## Product Change Notification

### PCN-PCC-2753-2018

Business Unit	Product Line Code	Type of Change	Action	Date of Issue
PCC - PCB Connectors	AAA	Product Change Notification	Notify Distributors and Field	11/19/2018

Previous Product	New Product
 <p style="text-align: center;">Complete gold-plating</p> 	 <p style="text-align: center;">partially gold-plated surface (plugging area)</p>

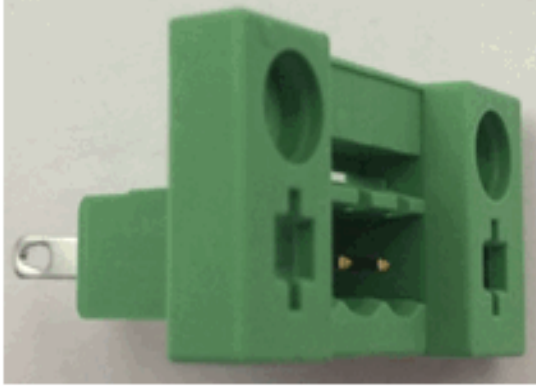
In order to optimized the production process we will be transitioning from a complete to a partial gold plating process. The new versions will have gold plating on the plugging area of the contact. The revision level (V/C) will be updated, and during the conversion process both versions may be available depending on local inventory levels.
